Gibbons Creek Environmental Redevelopment Group, LLC

September 6, 2022

Re: Technical NOD2 New CCR Registration  
Gibbons Creek Environmental Redevelopment Group, LLC – Anderson, Grimes County  
New Coal Combustion Residuals (CCR) Registration No. CCR113  
Industrial Solid Waste Registration No. 32271  
EPA Identification No. TXD000751073  
Tracking No. 27262344; RN100214550/CN6505860162

REVISED FIGURES

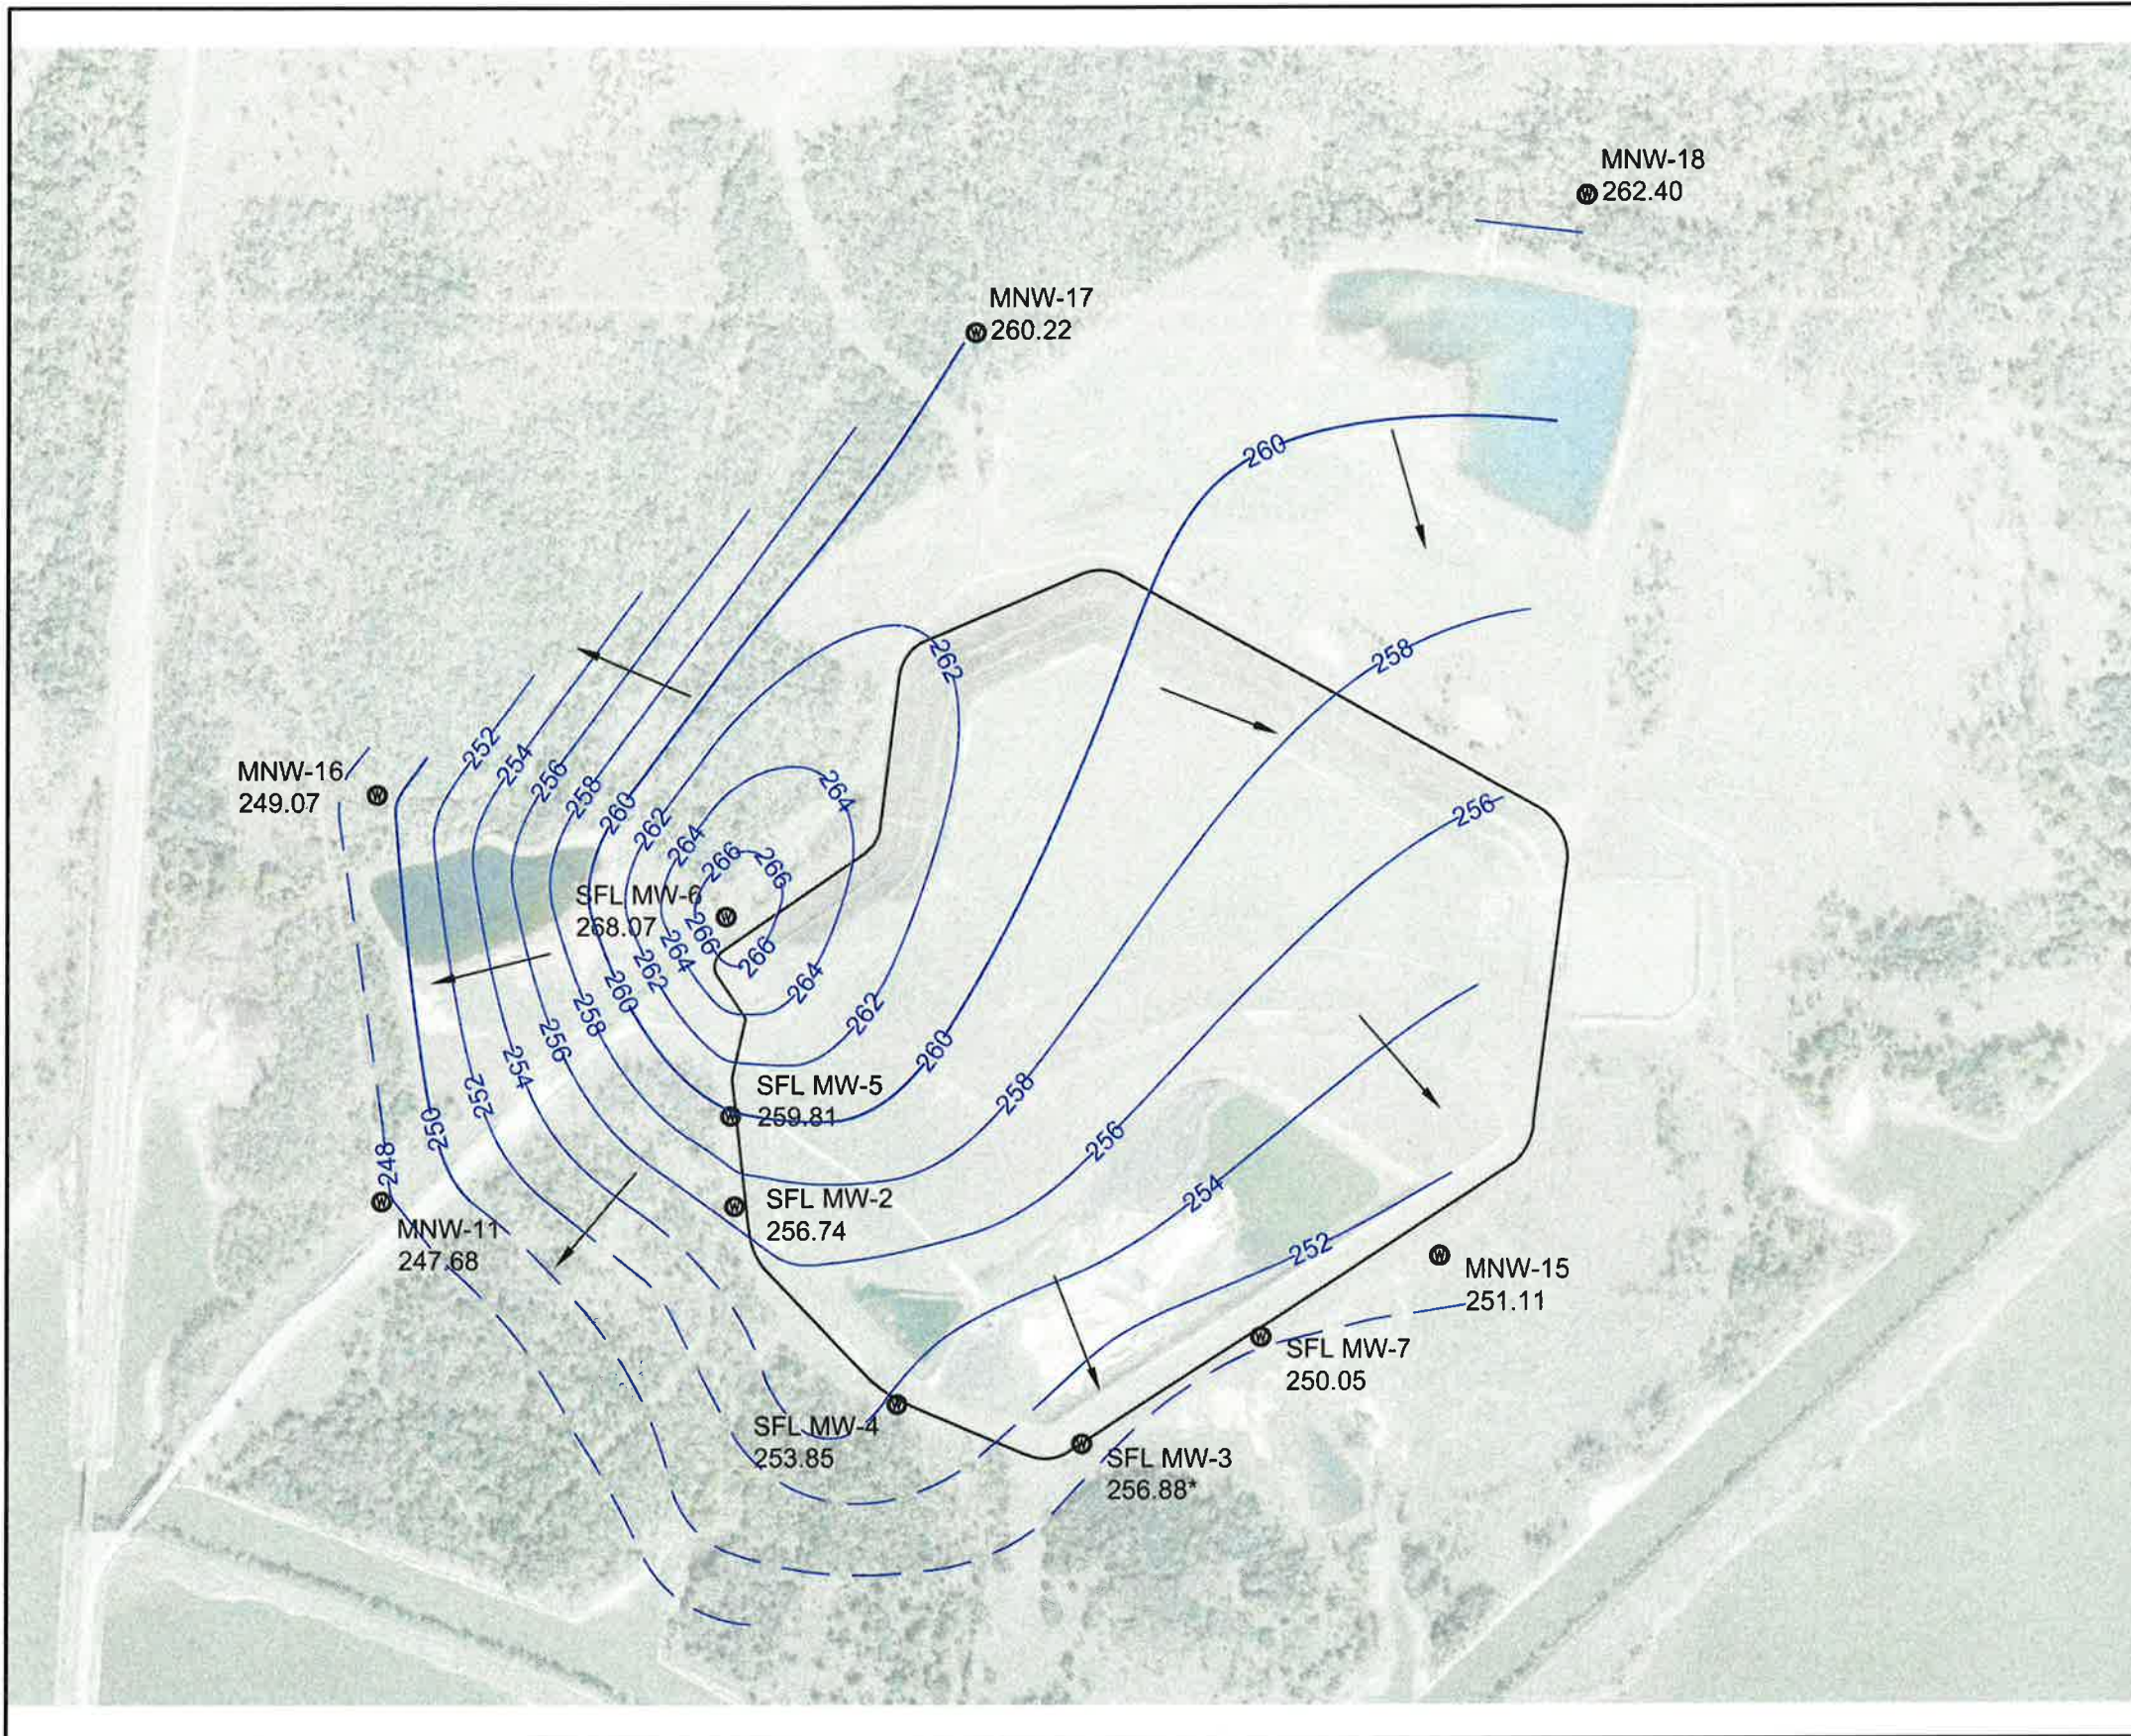
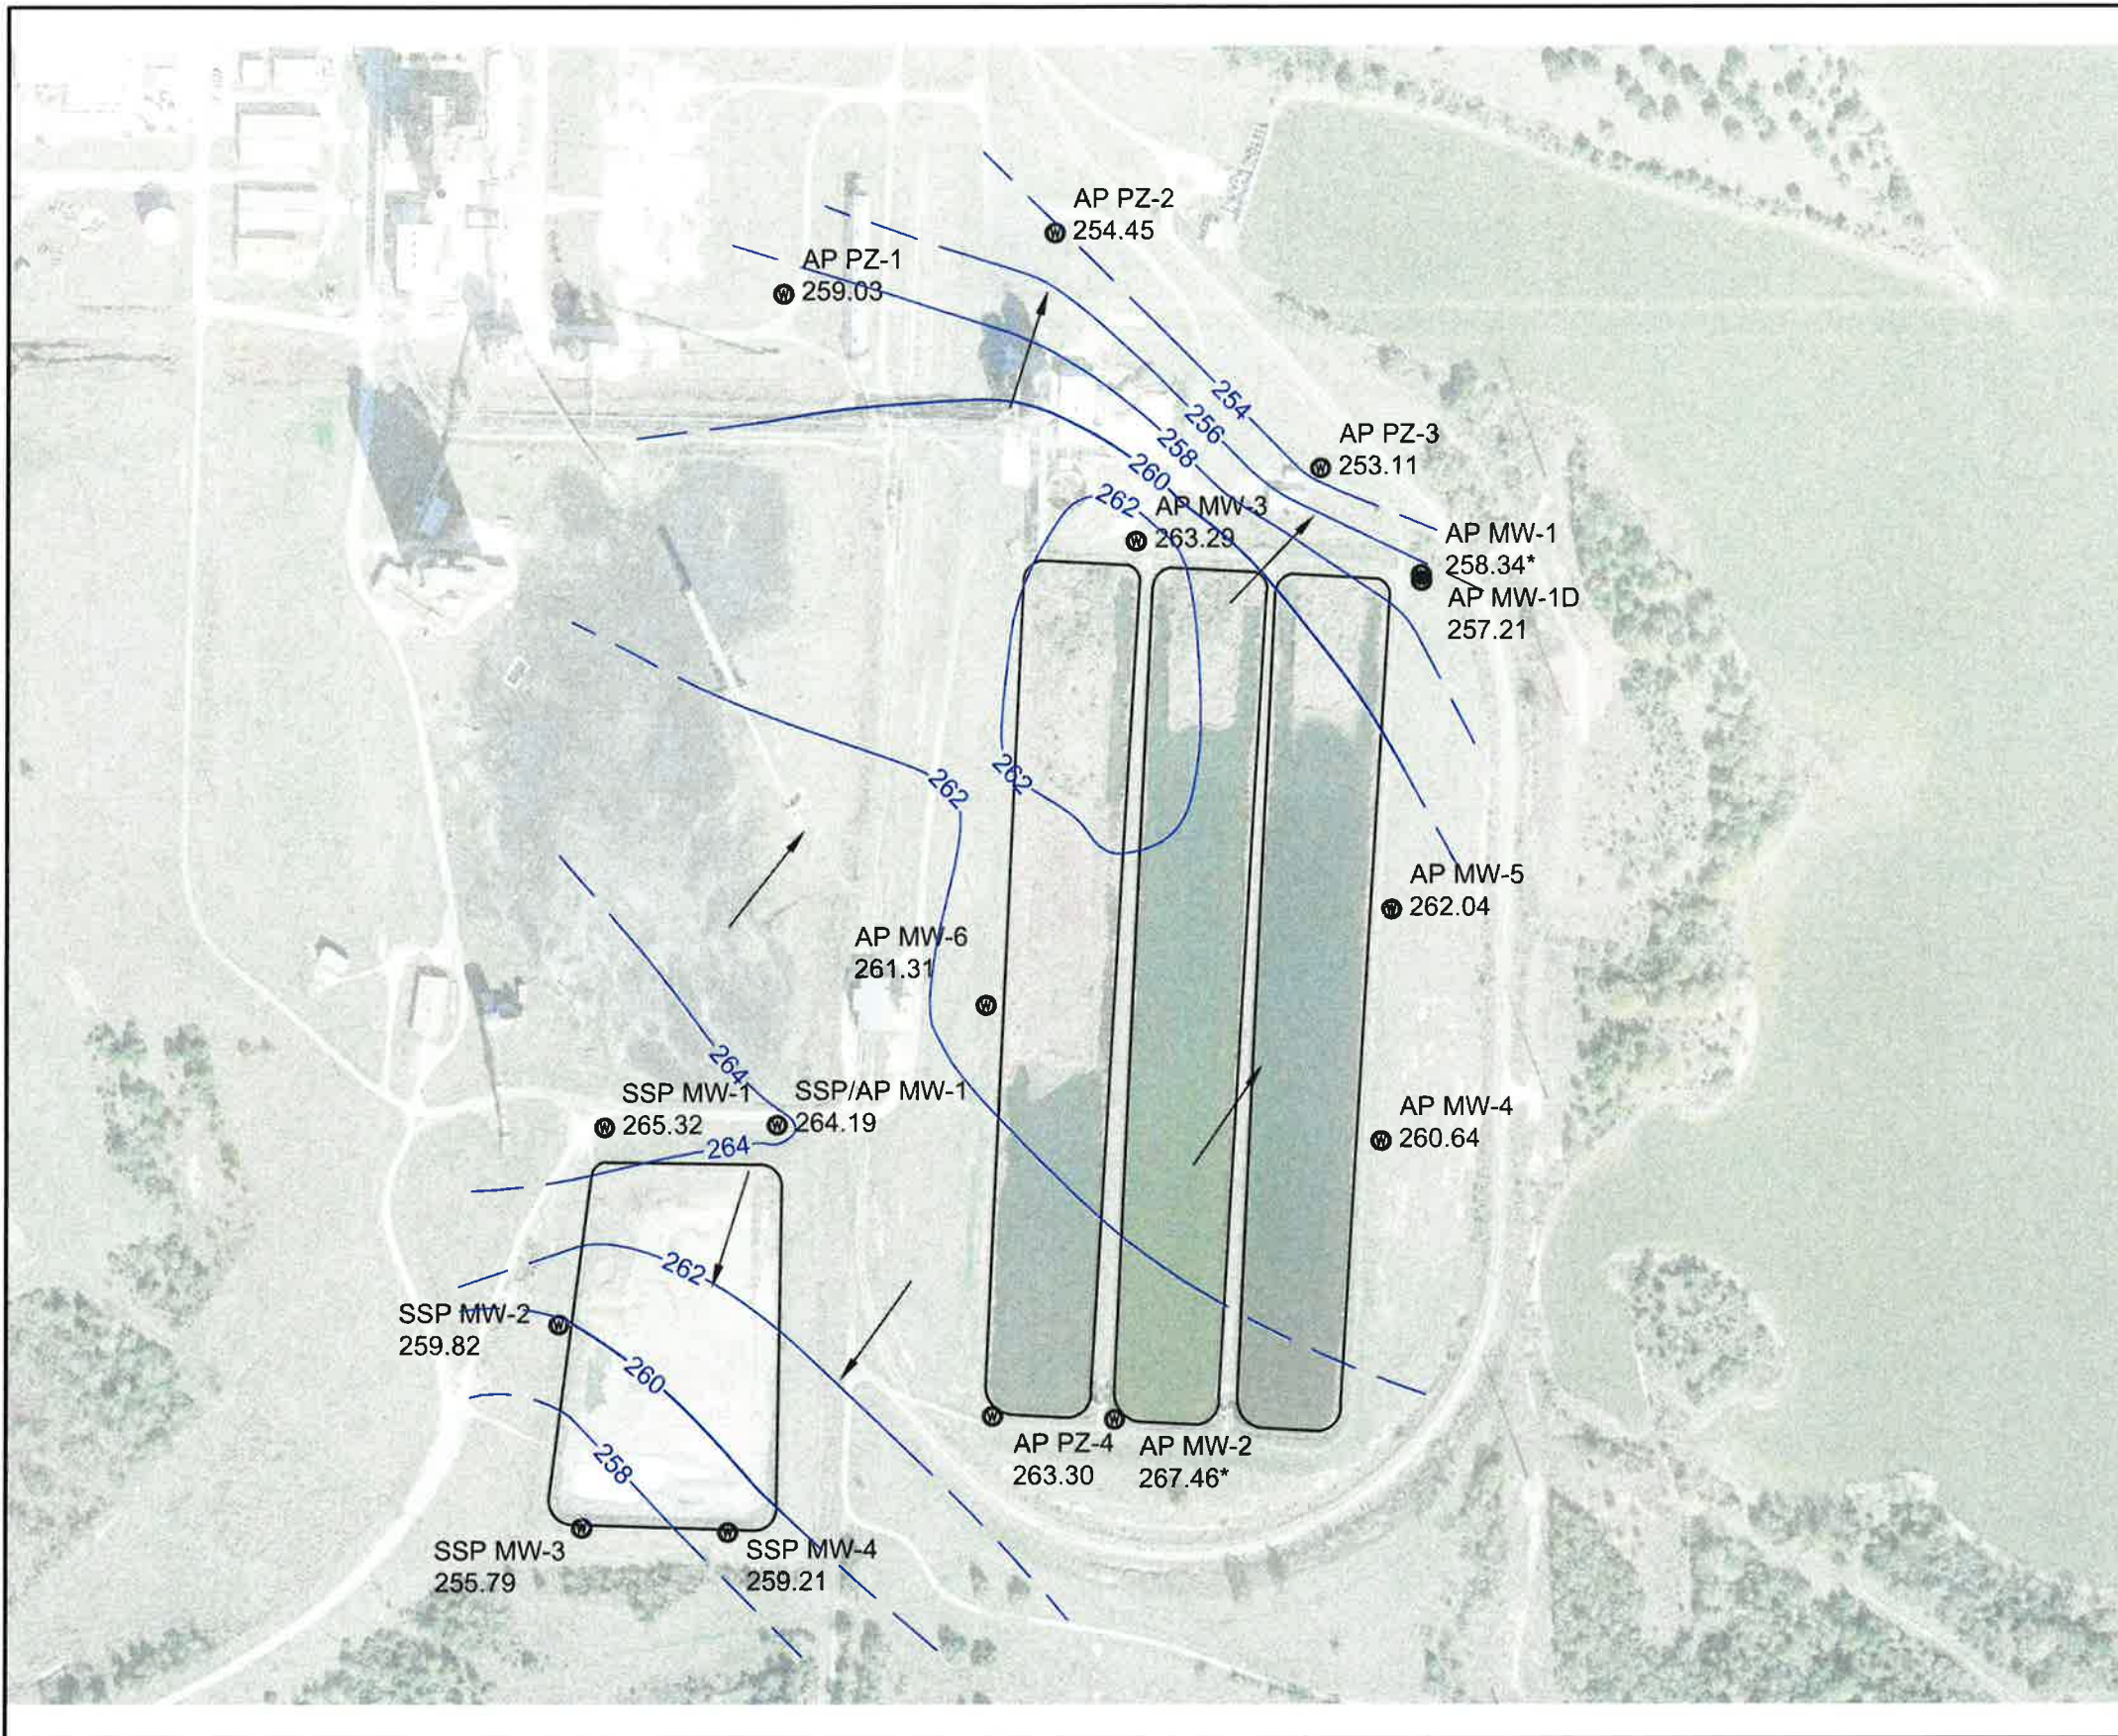
Provide reports and figures signed and sealed by a P.E.

*See response Item 22 Attachment for revised reports and figures.*
